PIKE SOLAR

GRADING, EROSION & SEDIMENT CONTROL PLANS

EPC STORMWATER REVIEW COMMENTS ARE SHOWN IN ORANGE BOXES WITH BLACK TEXT

PCD-ENGINEERING REVIEW COMMENTS IN BLUE BOXES WITH BLUE TEXT

SHEET
 51 OF 77

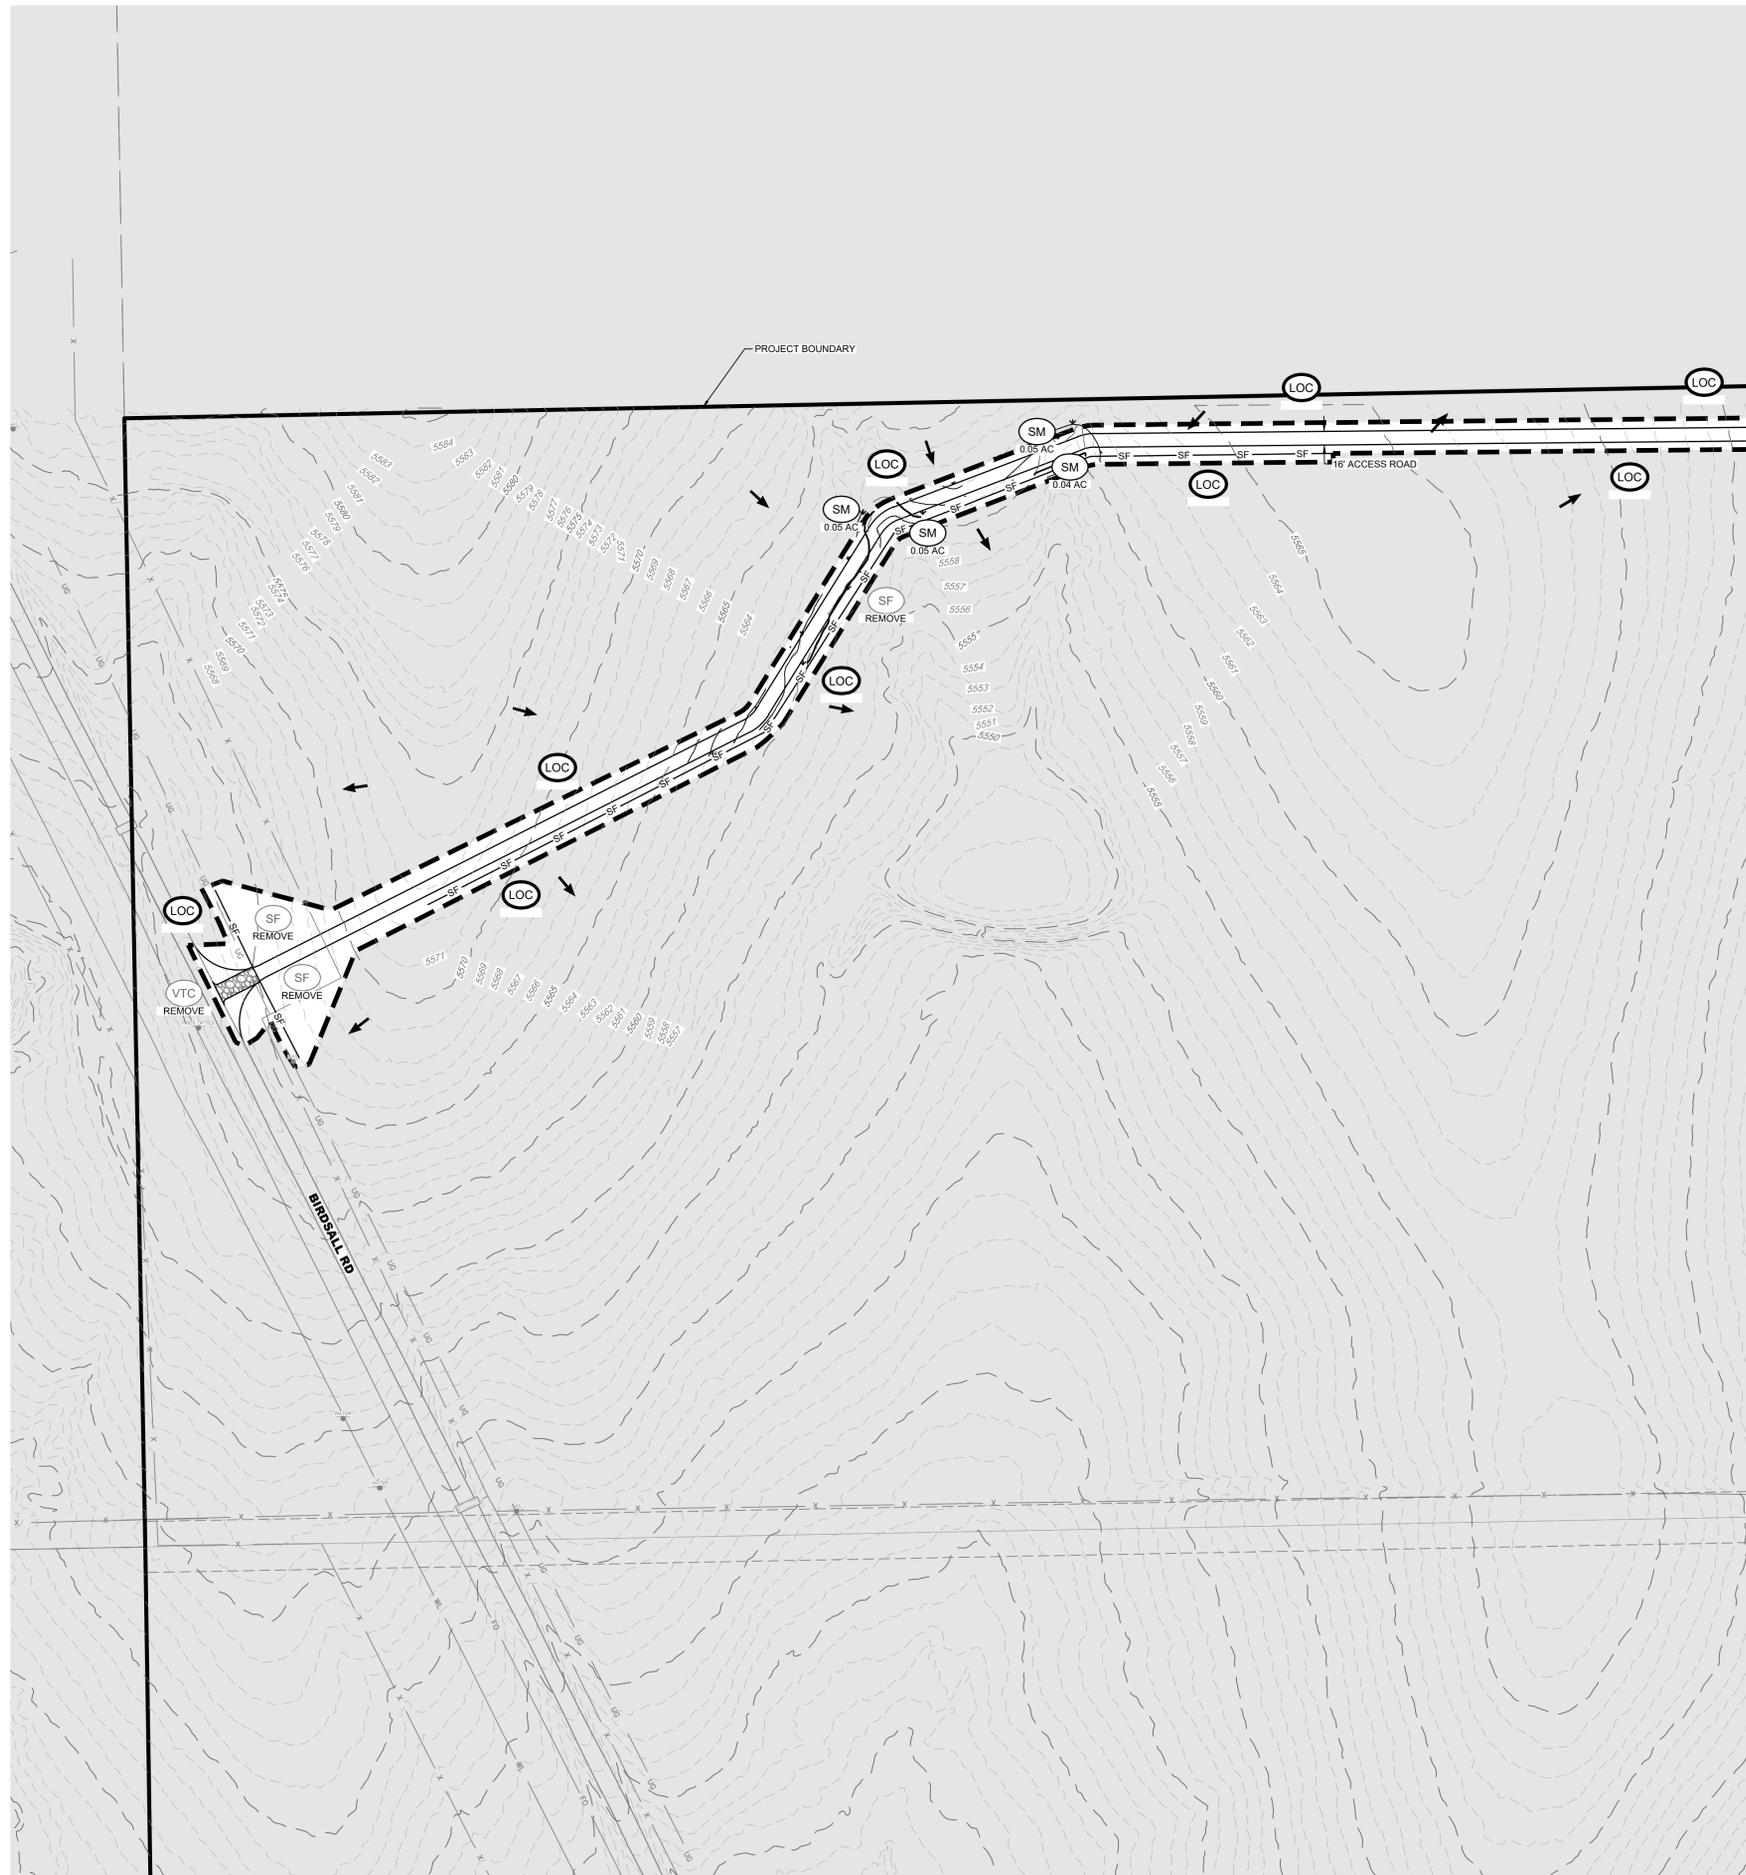
Do not show temporary BMPs on Final sheets or make symbols on sheets gray like text

show permanent seeding/mulching areas, areas to be paved, gravel areas to remain, etc. with hatching

Temporary BMPs grayed back.

A hatch has been added for areas to be paved or that will have gravel to remain.

SHEET
 65 OF 77

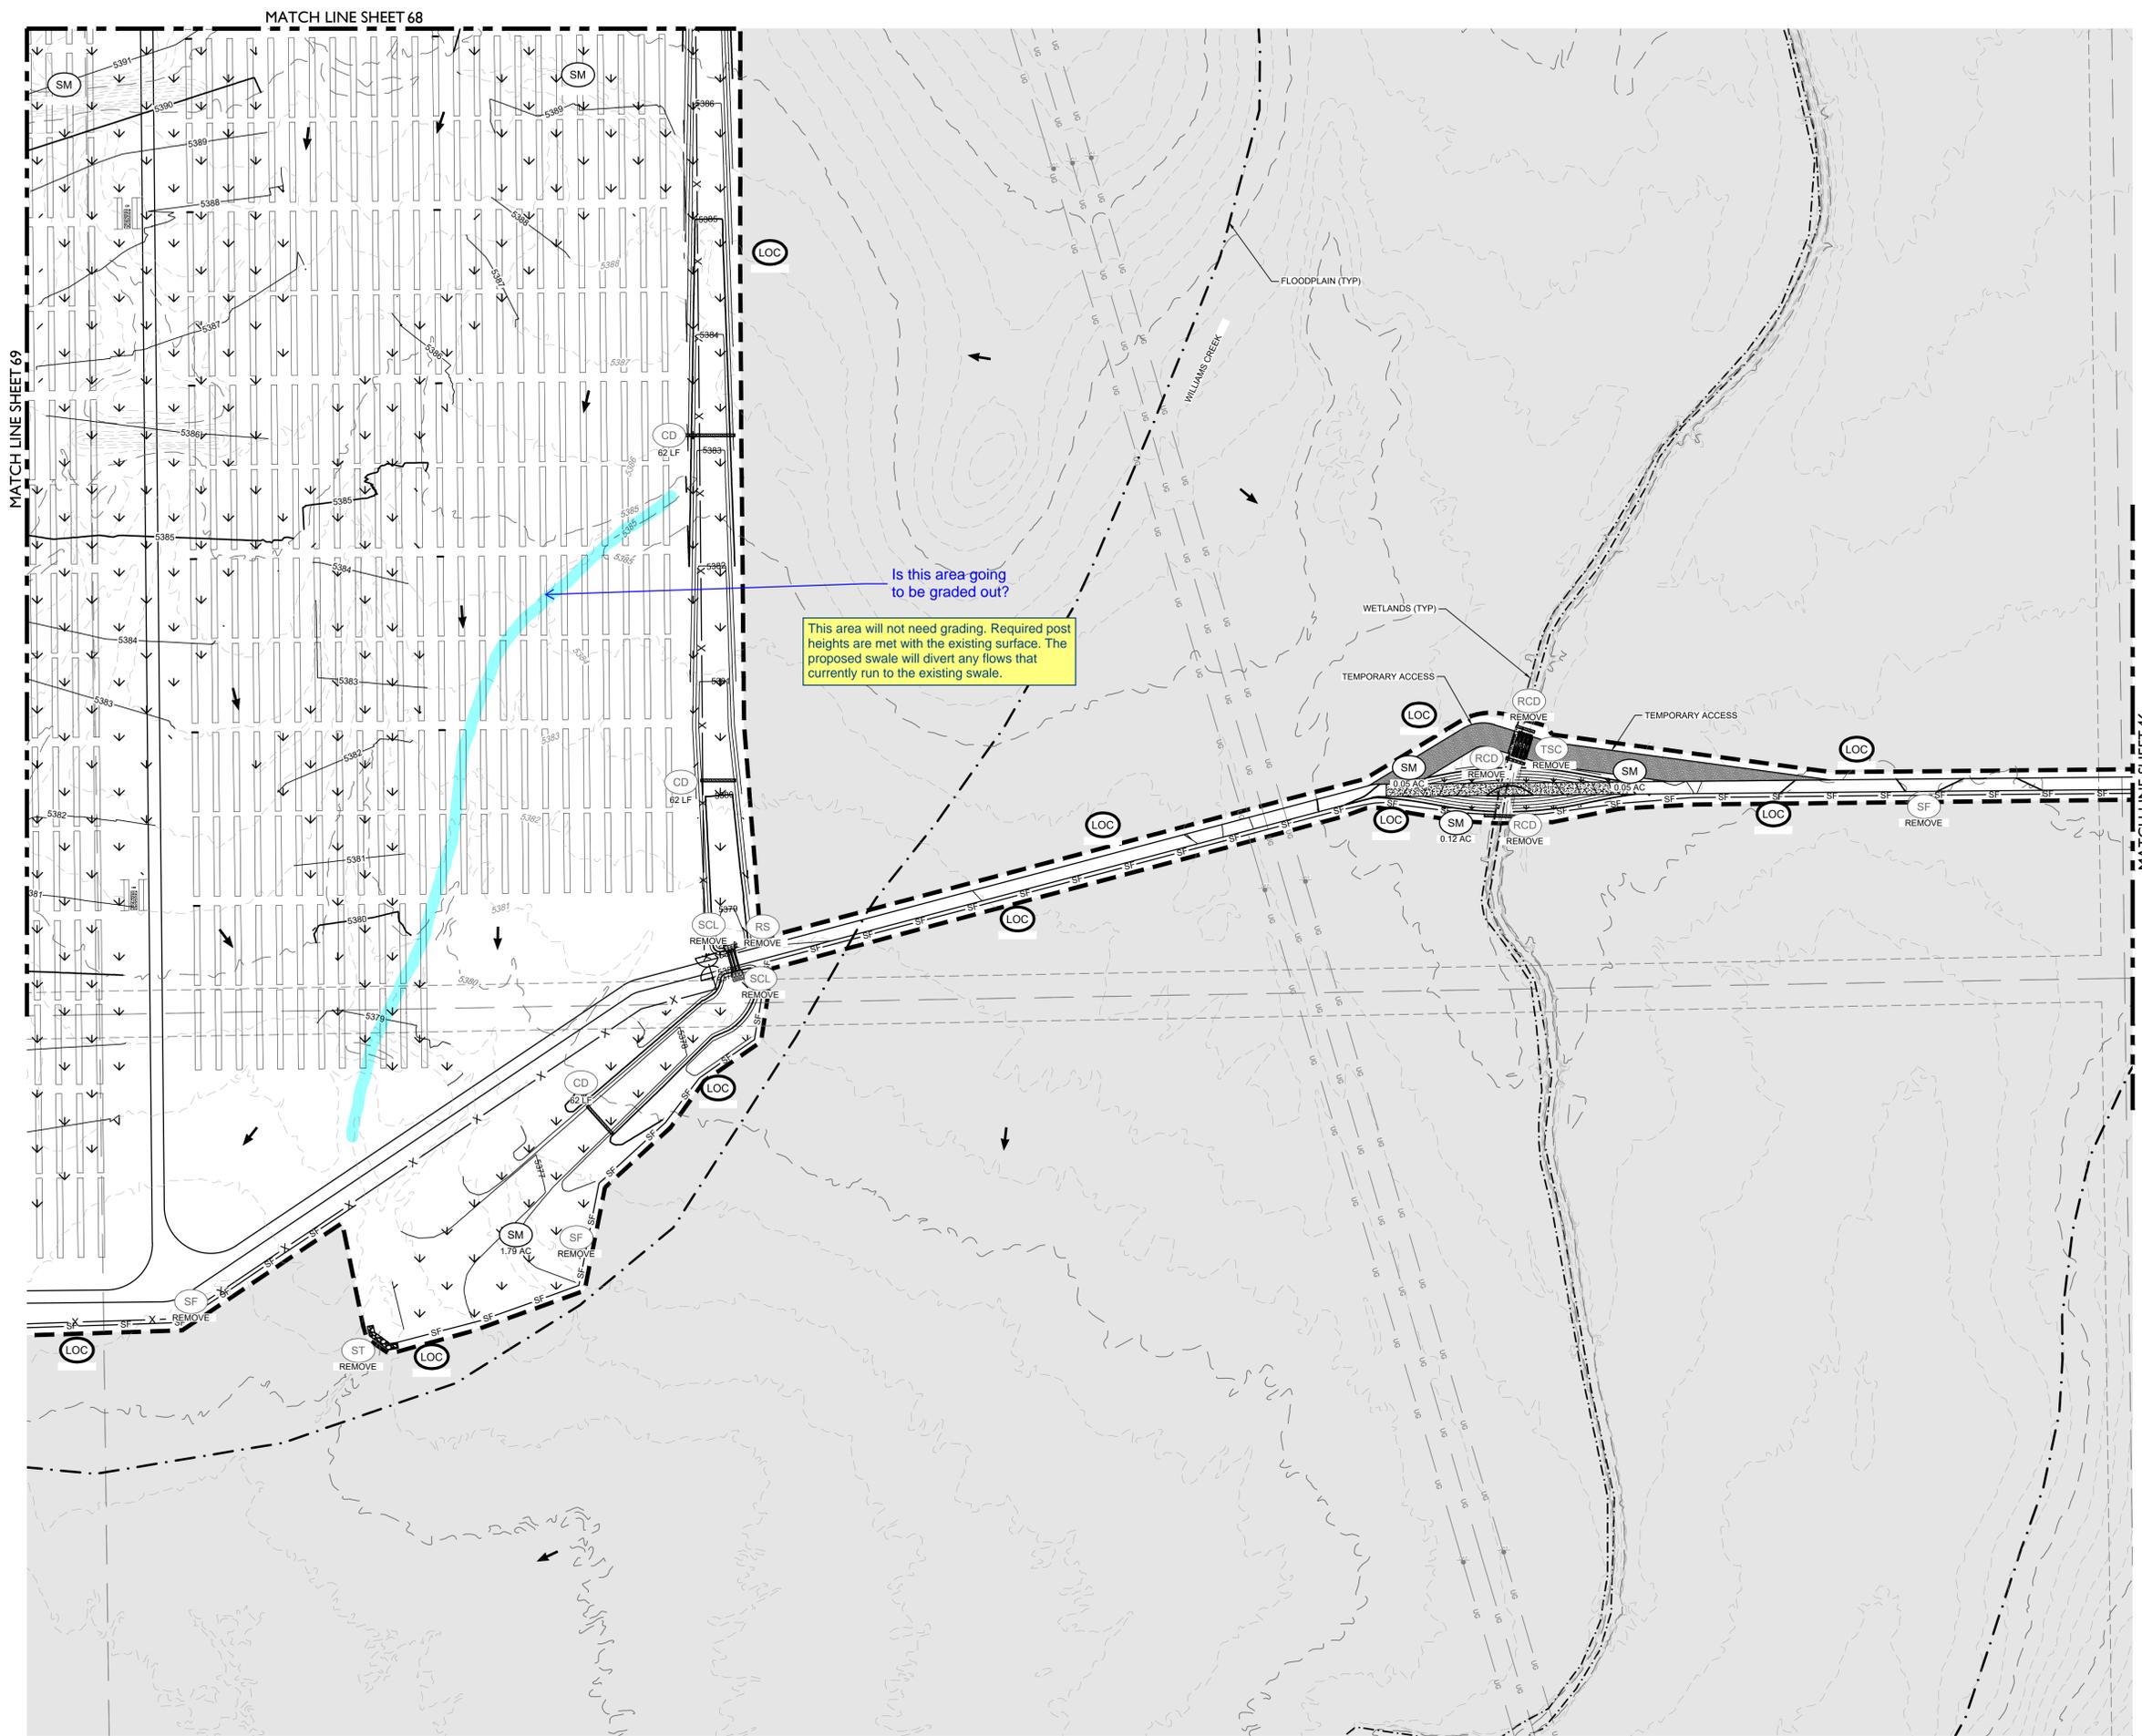
SB DESIGN
 DISTURBED AREA-10 ACRES
 VOLUME 1,005 CY
 CREST 10"
 HOLE DIA. 18"
 remove and seed/mulch area
 Pond removed for final stage and seeding added.

JOB NO.
20-194
SHEET
73 OF 77

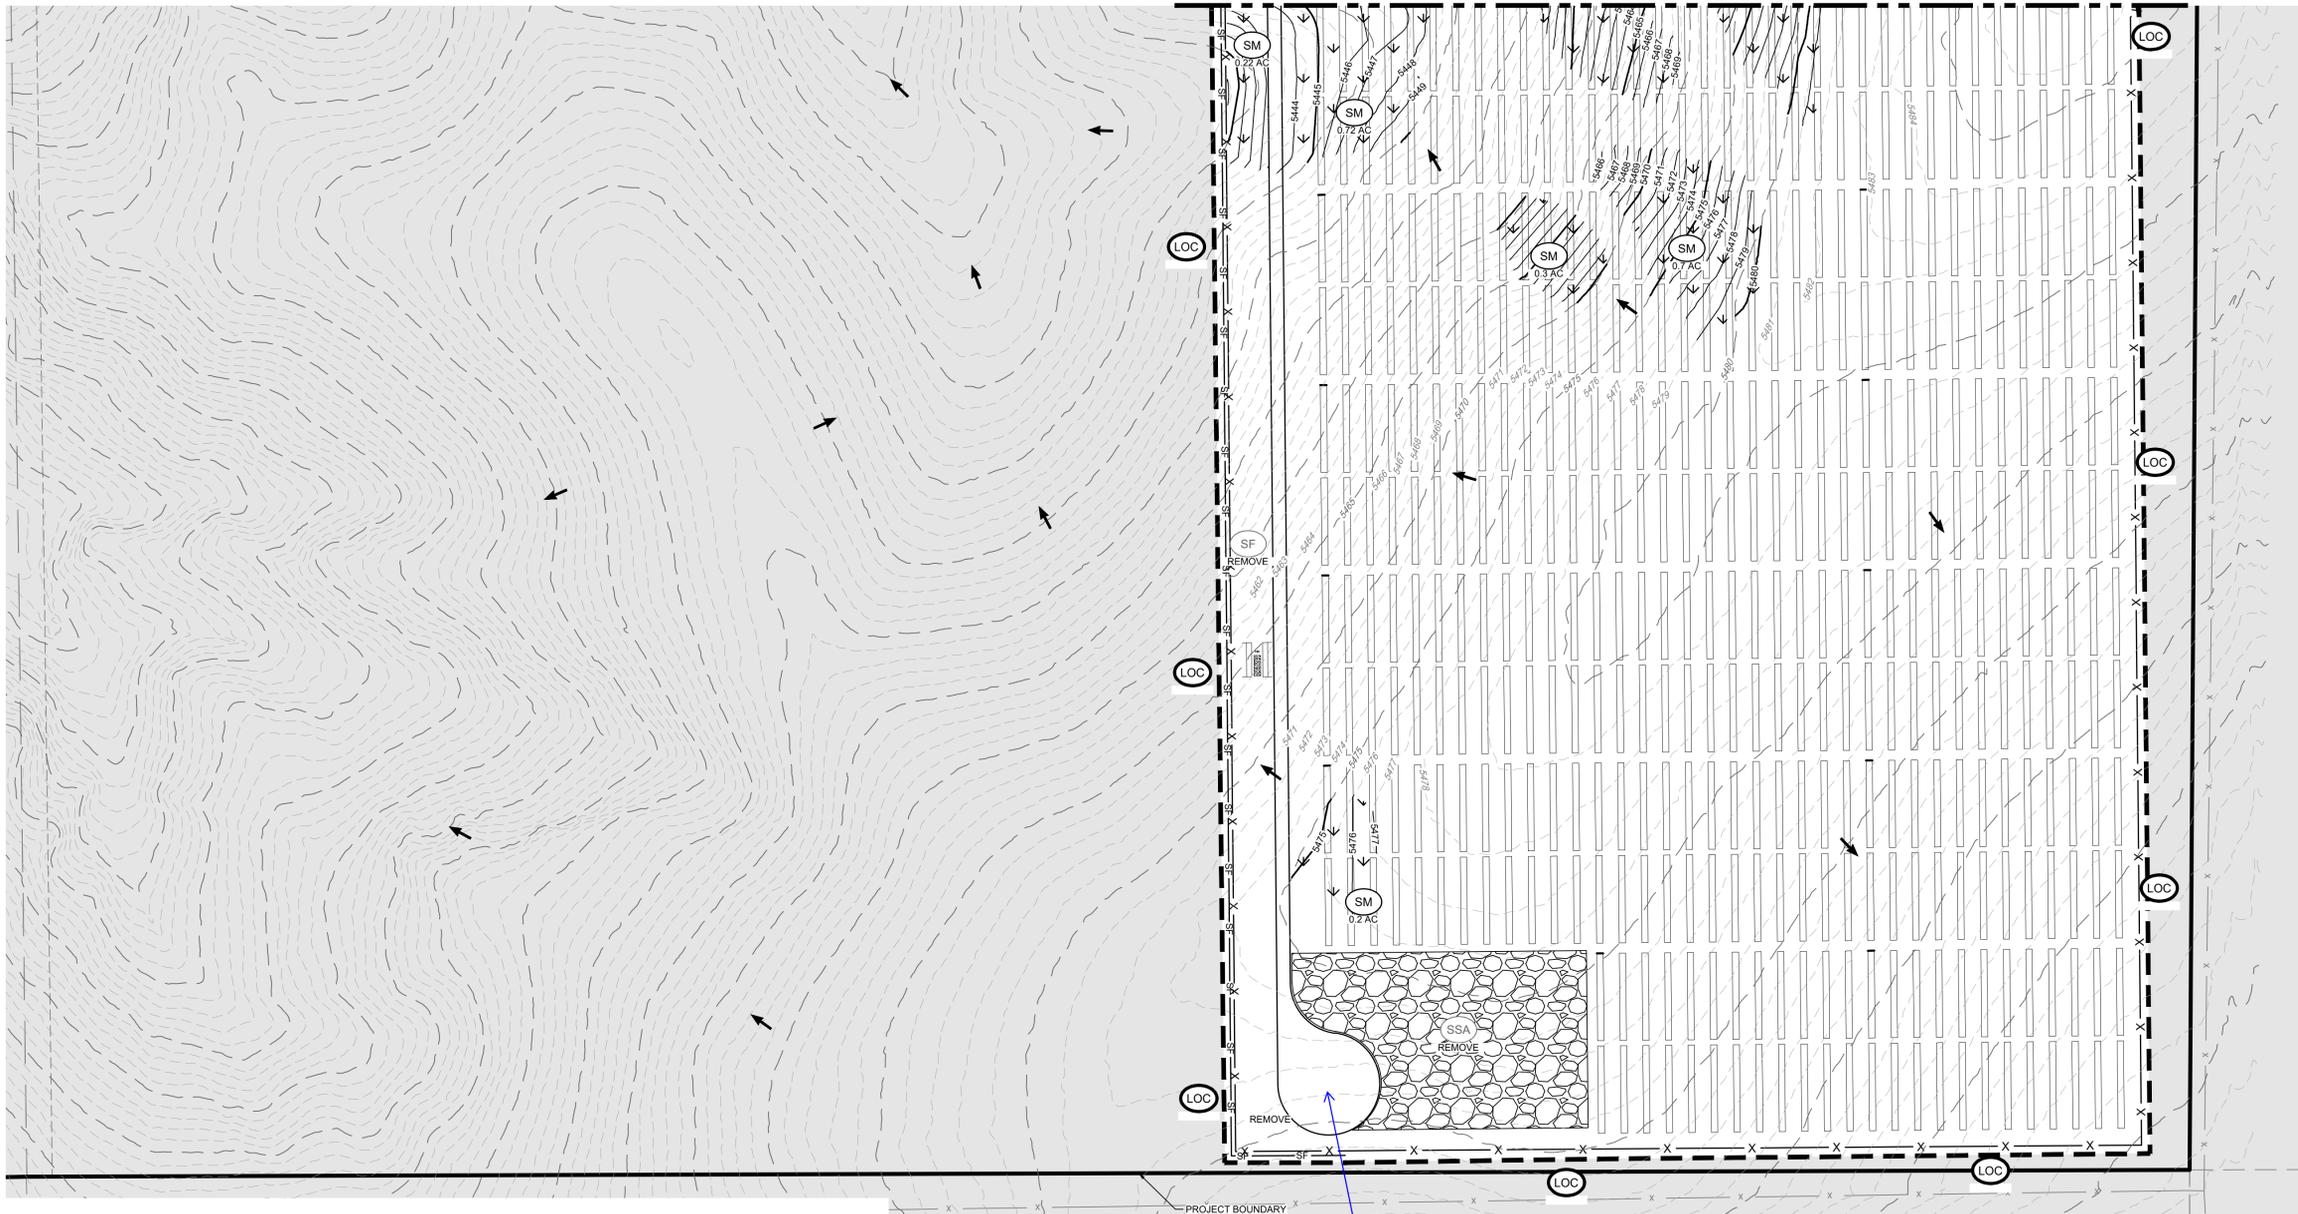
Please provide hatching for permanent access roads
Hatch added

JOB NO. 20-194
SHEET 76 OF 77

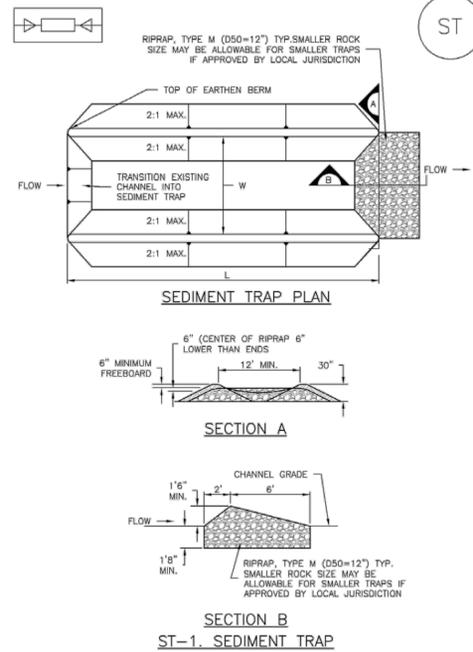
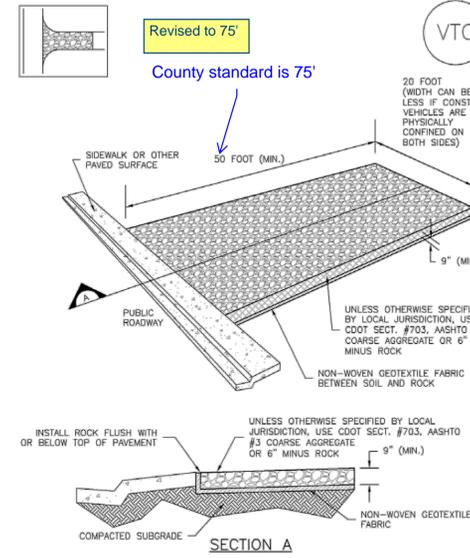
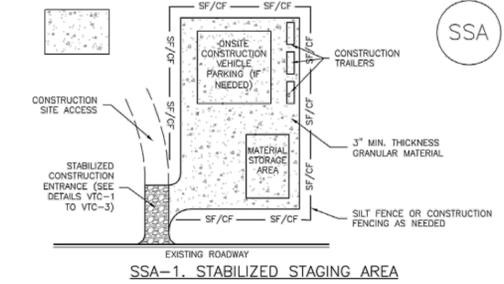
- (DETAILS ADAPTED FROM DOUGLAS COUNTY, COLORADO, NOT AVAILABLE IN AUTOCAD)
- Temporary sediment basin details added
- Provide details of temporary sediment basin including riser pipe perforation sizing, number of rows, required volume, location of outlet and spillway, and tributary area to the sediment basin.
